FIRE HYDRANT ASSESSMENT REPORT

SELL & PARKER, BLACKTOWN

45 Tattersall Rd, Kings Park NSW 2148

Date: 15 June 2020
Revision: 2
Issue: Issued to Client
Ref. No.: 21000_FHAR

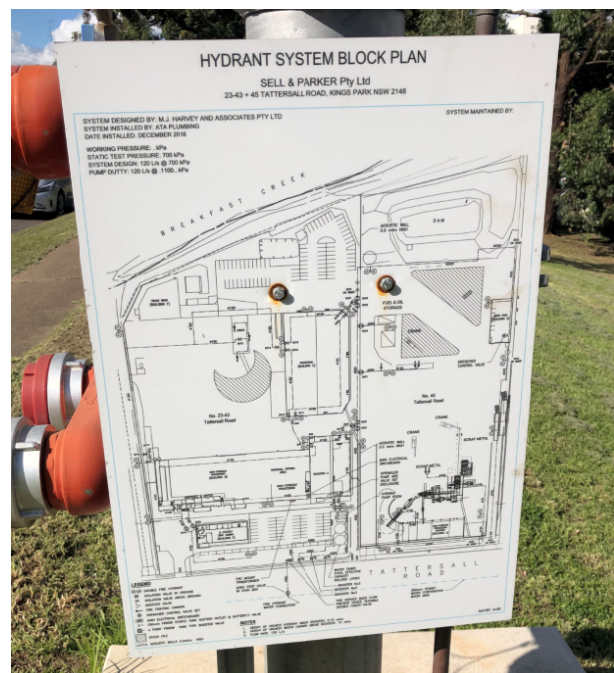
It was observed that the existing booster valves are not secure or locked in the open position.

1. The existing booster assembly is non-compliant due to the booster valves not being secure or locked in the open position.
2. The booster inlet pipes do not have an isolation valves downstream of the booster inlets. Booster inlet pipes are required to have an isolation valve if the head at the inlets can be greater than 50kPa due to the pumps running.
3. No signage to identify the booster assemblies in accordance with Clause 7.10 of AS2419.1 – 2005.
4. FH Block plan has incomplete and incorrect information in accordance with Clause 7.11 of AS2419.1 – 2005
5. The fire brigade hardstand was observed to be non-compliant at the time of inspection due the fire brigade booster assembly being obstructed by parked cars.
6. Boost and Test Pressure signage is not provided for the boosters.

1. The booster valves shall be secured in the open position with a padlock openable by the fire brigade 003 key.
2. Isolation valves shall be provided downstream of the booster inlets.
3. Provide separate stands for signage of

the 'FH Booster' and must be adjacent the suction and inlet points to avoid confusion with the adjacent sprinkler booster.

4. Revise Block plan layout to show the actual configuration of the system including FH30 outside Building B, north arrow, connections for fire monitors, standard of compliance and electrical substation. The location of FH25 adjacent the weighbridge shall be updated on the block plan to reflect the accurate location.
5. The fire brigade hardstand shall not be used as parking. Request council to move no-parking sign beyond booster assembly to keep front of boosters clear at all times.
6. Provide a fade-resistant or engraved sign indicating boost and test pressure in kPa, marked in upper case lettering not less than 25mm in height

Location of FH24

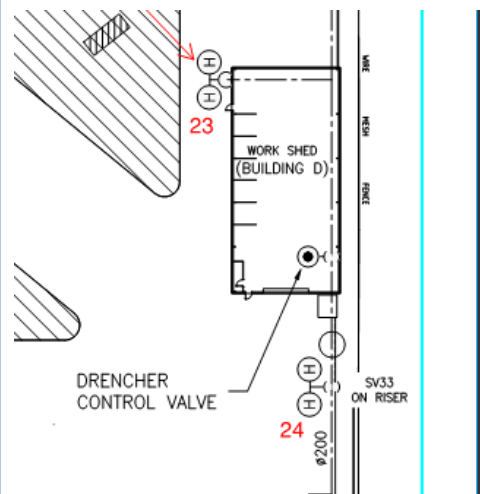
It was observed during the inspection that FH24 was obstructed by existing sheds and did not have a cover.

1. The existing fire hydrant system is not compliant due to the fire hydrant accessibility being obstructed by the existing sheds.
2. The existing fire hydrant system is non complaint due to the fire hydrant outlet without having a protective cap to block debris and other contaminants from entering the pipes.

1. The fire hydrant shall be relocated to an accessible location in front of the sheds.
2. The fire hydrant shall be kept covered when not in operation. Caps shall be provided to missing fire hydrants.

Risers entering Building B from SV1 and SV2 without bollard protection

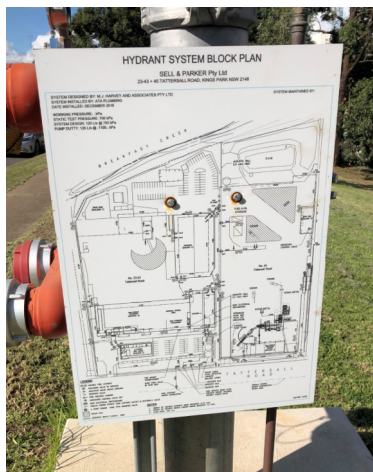
The existing fire hydrant system has pipework and in areas with moving vehicles, without protection of damage from the vehicles.

The existing fire hydrant system is non complaint because AS2419.1 requires fire hydrants and pipework to be located so that the fire hydrant system is protected from possible mechanical damage by vehicles. The following pipes are required to, but did not have any protection from physical damage:

- Risers entering Building B from SV19 and SV20
- Risers entering Building B from SV1 and

The risers serving Building B from shall be provided with bollard protection from moving vehicles.
